Access Compliance Report

Public Rights-of-Way

(Pedestrian Signals)

Intersection ID: N/A	Main Street:	Cross Street: N/A	Location: N/A
ADA ID: C1C7D5BC90B8	Signal Type: Two Push Buttons-Non APS	Overall Compliance: No	Severity Score: BTN 1:N/A BTN 2: N/A No BTN: N/A
Codes/Mitigation Info/Possible Solution		Field Measurements/Component Compliance

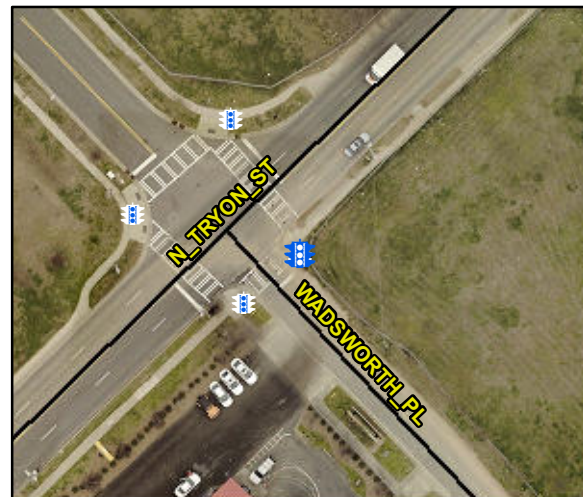
Surveyor Notes: TEXT HT 1/2

PROW/ADA: R410.6, TMUTCD 4e.08, R404.2, R404.3, R404.7.3, R406.2

Possible Solutions: Replace Signal Push Button With APS Button on New Post. Remove & Replace Sign.
